Seismic Walkdown Checklist (SWC) SWEL1-064

Equipment ID No. 31PP

Equipment Description 125VDC POWER PANEL 31

Note:
Through bolts from panel side

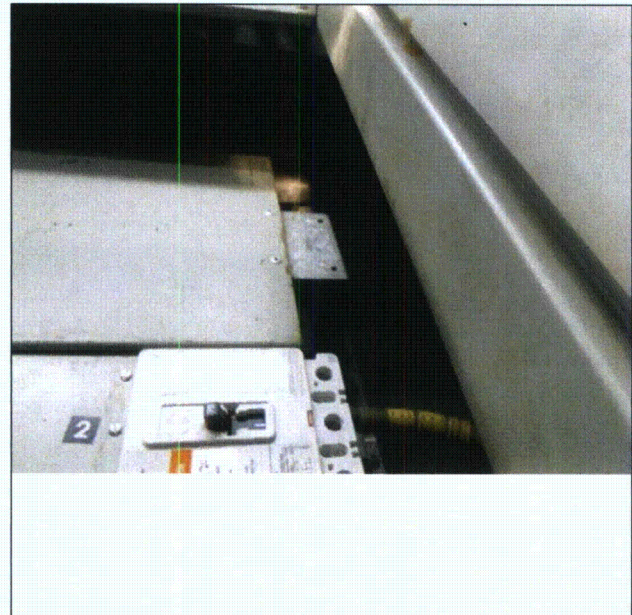
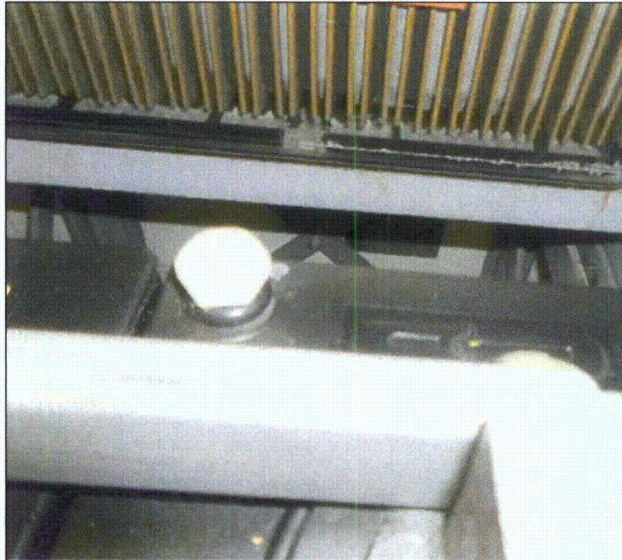
A drawing of the panel anchorage shows 6 bolts. Inspection of the anchorage was performed inside Battery Room 31 and verified to be (6)- 3/4" through bolts.

Anchorage details provided in SEWS for 125 VDC Power 31 conservatively used (4) - 3/8" Wegit bolts even though verified to be through bolts. The allowable capacity for the (4) - 3/8" Wegit bolts are much smaller than the actual capacity of the (6) - 3/4" through bolts used.

PRESSURIZER LEVEL TRANSMITTER CABINET
Rack 19

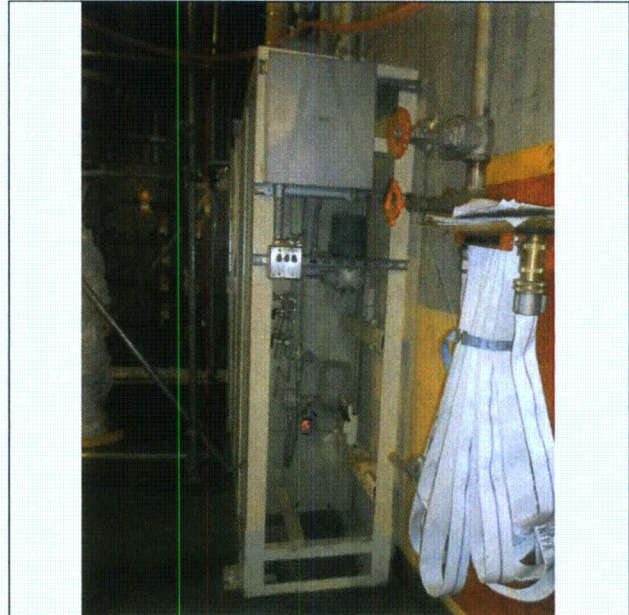
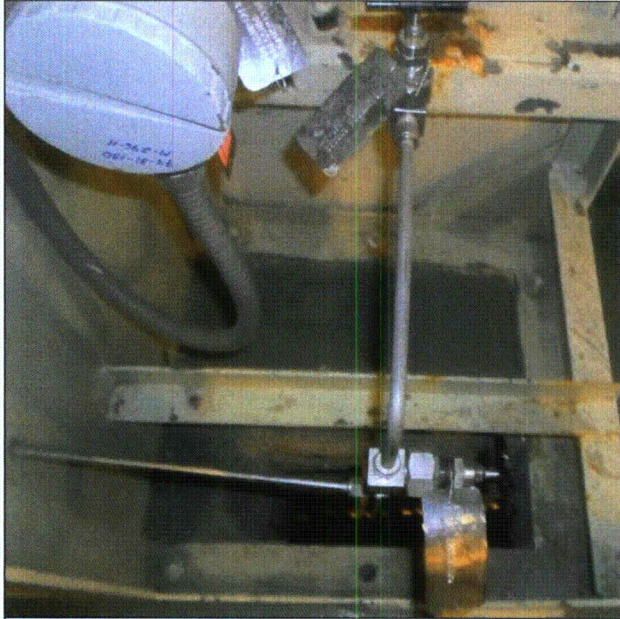
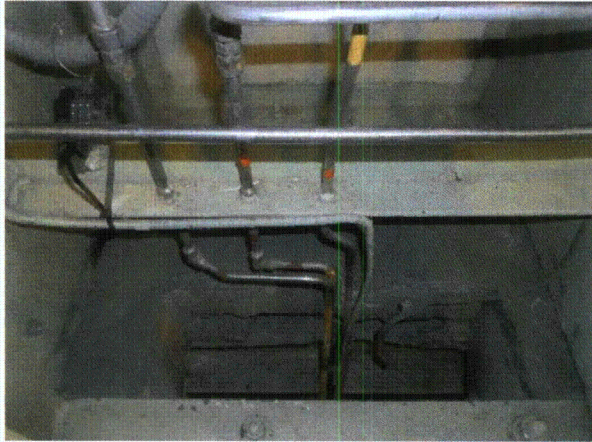
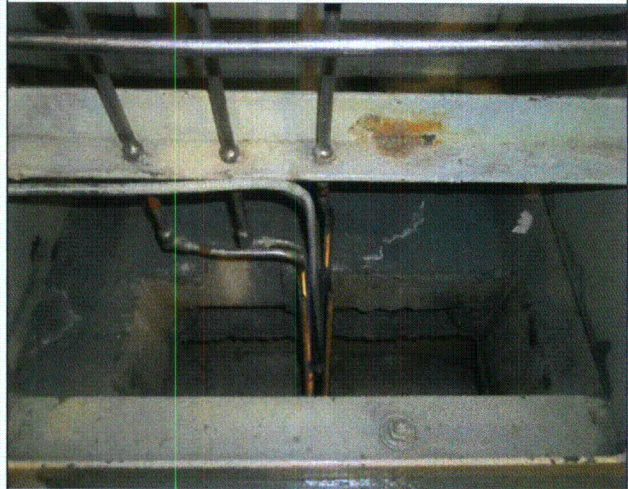
1. The drawing shows all anchor bolts are 0.75 inch but the bolts are all 0.5" diameter.
2. The drawing shows 16 anchor bolts but the as built condition shows 8 of them were not installed. (Note: One compartment cannot be accessed with a sign "Door to Remain Closed at all Times").
3. Section A-A of Dwg. 9321-F-70553 is typical for both Rack 19 and 21. The two racks must have their own individual anchorage plan because the two configurations, including proximity to the edge of floor penetrations, are different.

*CR-IP3-2013-01346 was generated to resolve the above issues. (The CR incorrectly stated that 17 bolts were shown on the drawing)
 There is no operability concern because the existing SQUG evaluation of the rack bounds the discrepancies noted above. The as built configuration is structurally adequate when analyzed for seismic loads associated with a postulated SSE occurrence. The calculation for this rack needs to be revised.
 The drawing needs to be revised to show the actual as built configurations for the rack.*
